PCN-20171115 TE0803-01 SPI Flash Change

Company	Trenz Electronic GmbH
PCN Number	PCN-20171115
Title	PCN-20171115 TE0803-01 SPI Flash Change
Subject	BOM change
Issue Date	20171115

This change affects all Trenz Electronic TE0803 SoMs: TE0803-*.

#1 Change SPI Flash from N25Q256A11E1240E to N25Q512A11G1240E

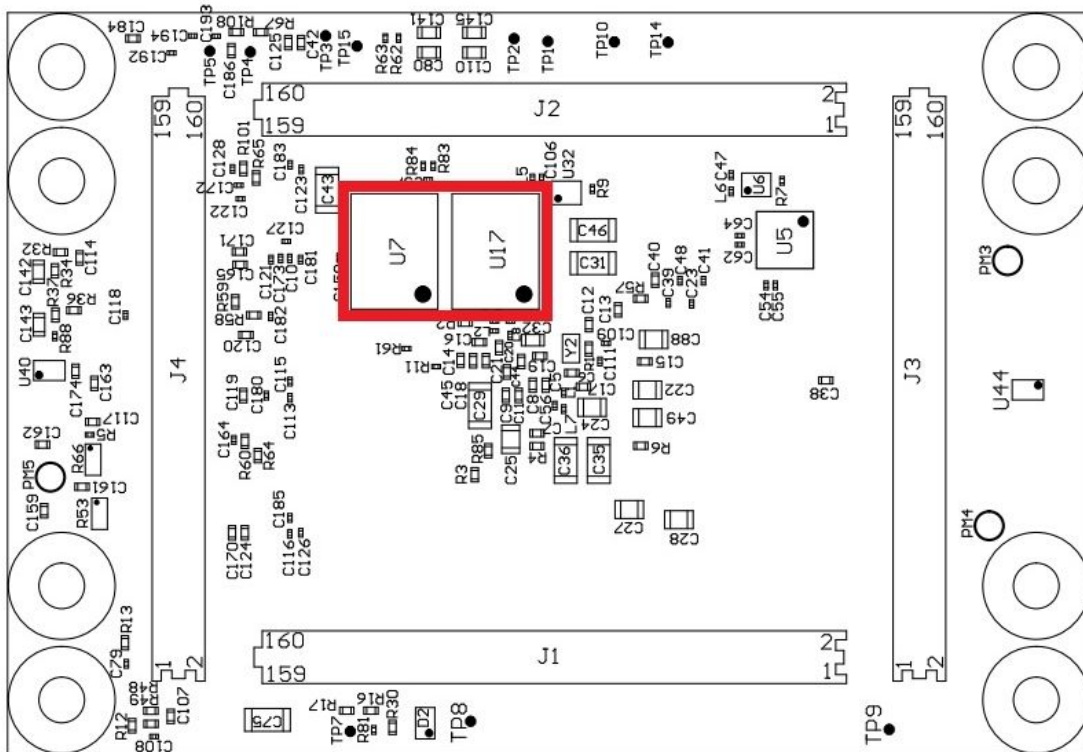
Type: BOM change

Reason: N25Q256A11E1240E became obsolete, replacement part not available for purchase. This is only interim solution because N25Q512A11G1240E is also obsolete already. It will be changed after the replacement parts get available.

Impact: Size changed from 256 MBit to 512 MBit per chip. JEDEC ID changed from BB19h to BB20h both with manufacturer ID: 20h.

Locate Flash on backside of PCB:

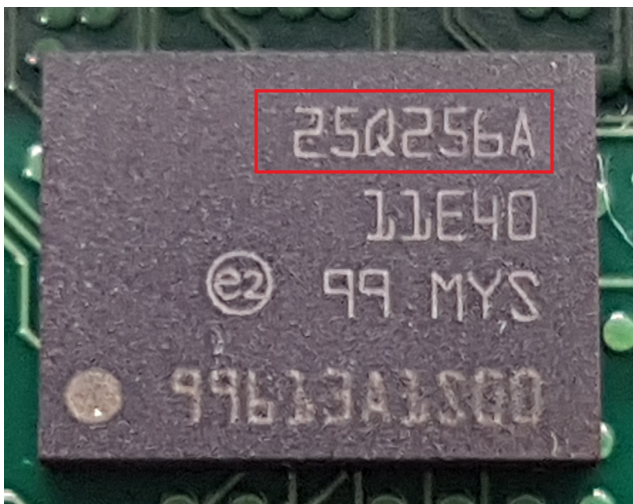
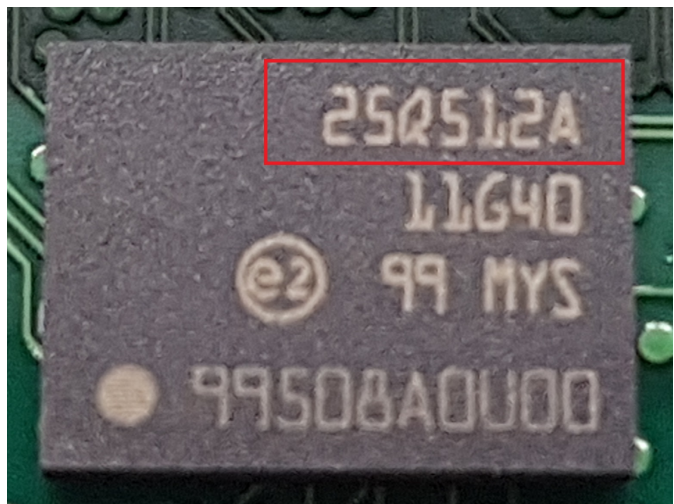
N25Q256A11E1240E

N25Q512A11G1240E
